DATE: March 5, 2026

ADDENDUM NO. 3

PROJECT NO. DGS C-0576-0012 PHASE 001
PROJECT TITLE - SCI Chester - Electrical Upgrades

H.F. Lenz Co.
1407 Scalp Avenue
Johnstown, Pennsylvania, 15904

DRAWN BY E. HOOVER	DATE 21 NOVEMBER 2025	DRAWING NO. E-501
CHECKED BY S. MULHOLLEN	SCALE 12" = 1'-0"

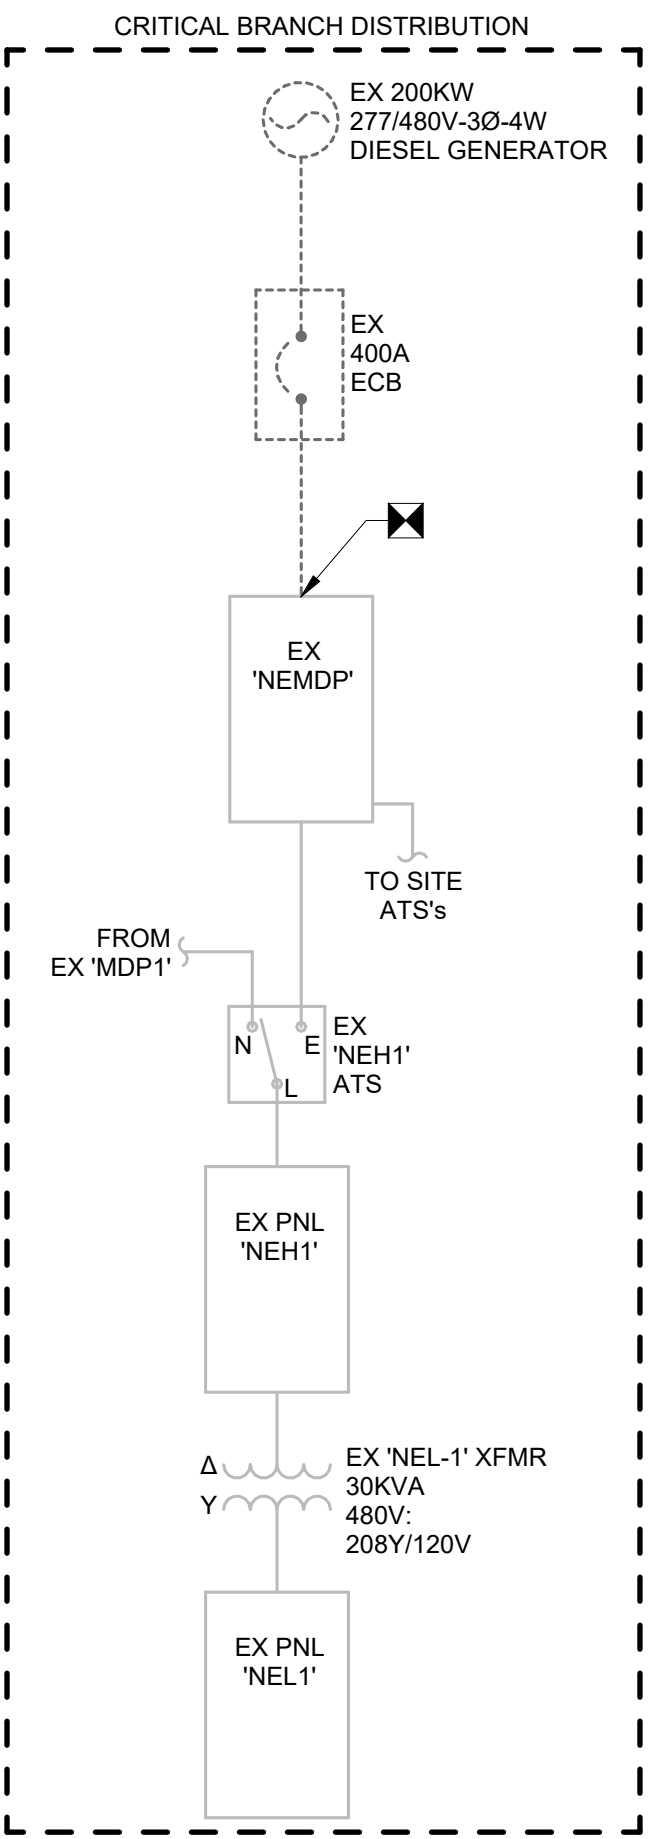
1. Drawings E-101, E-102, E-103, E-104, E-105, E-501, E-502, E-503: Voltage feeding 'EX 15KV SWGR' revised to read: "EX UTILITY FROM PECO 13.2/7.62KV"
2. Drawing E-102: Reference markers on 1/E-102 revised to reference drawing E-102.
3. Drawing E-301:

6 EMERGENCY LIGHTING INVERTER SCHEMATIC WIRING DIAGRAM

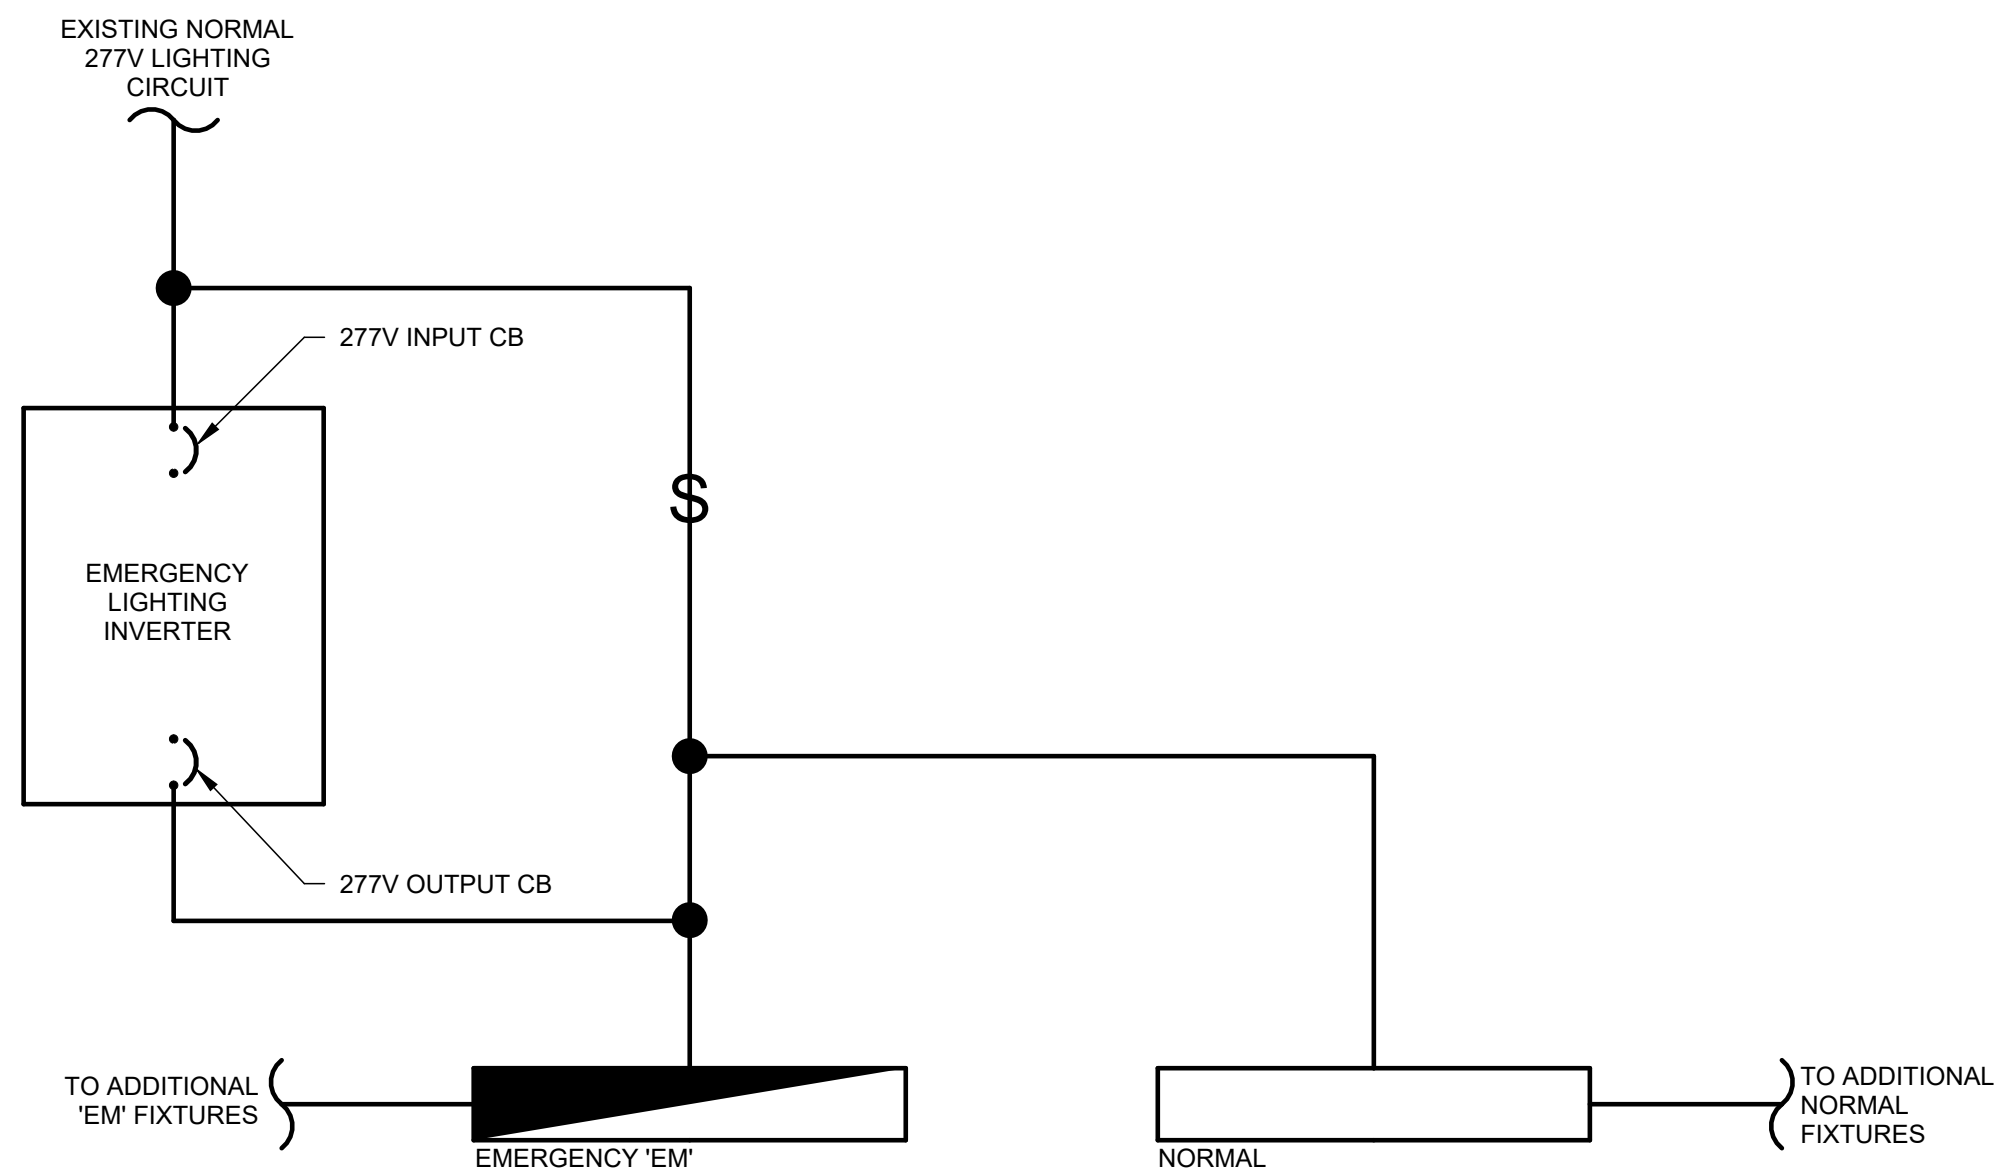
4. Drawing E-602: Detail 6 'EMERGENCY LIGHTING INVERTER SCHEMATIC WIRING DIAGRAM' added.
5. Drawing E-702: Enclosure on SWGR 'MVDS' schedule revised to 'NEMA-3R'.
6. Drawing M-102: Added existing equipment to roof and plan note that reads: "DISCONNECT EXISTING EQUIPMENT IN ITS ENTIRETY & RENDER SAFE FOR REINSTALLATION."
7. Drawing M-202: Added existing equipment to roof and plan note that reads: "REINSTALL EXISTING EQUIPMENT"

9. Question: Dwg E-201 Keynote 2 states, "PROVIDE TWO (2) 2200VA EMERGENCY LIGHTING INVERTERS AT THIS LOCATION. LIGHTING INVERTERS SHALL BE FLOOR MOUNTED AND STACKED, 'INV1' MOUNTED LOW AND 'INV2' MOUNTED HIGH. REFER TO DETAILS IN E600 SERIES FOR ADDITIONAL INFORMATION." However, we are not seeing a detail in the E600 series for the lighting inverters. Please advise.

Response: Added Detail 6 on Drawing E-602 "EMERGENCY LIGHTING INVERTER SCHEMATIC WIRING DIAGRAM".
